#### 91 Poor sound reproduction from front bass speakers

91 19 38 2051051/2 February 13, 2019. Supersedes Technical Service Bulletin Group 91 number 18-91 dated April 23, 2018 for reasons listed below.

Model(s)	Year	VIN Range	Vehicle-Specific Equipment
A4, A5	2017 - 2018	All	Not Applicable

Figure 2. Signs of water on the speaker.

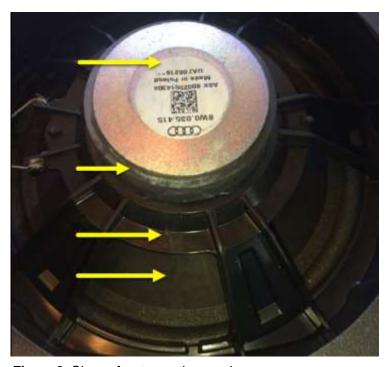
There is water damage to the label. Traces of water are found on the magnet, basket, cone, and surround of the speaker (Figure 2).

2. Replace both front door speaker woofers with part number 8W0035415A.

Both front door speakers must have the same part number. A mixed part number installation is not allowed.
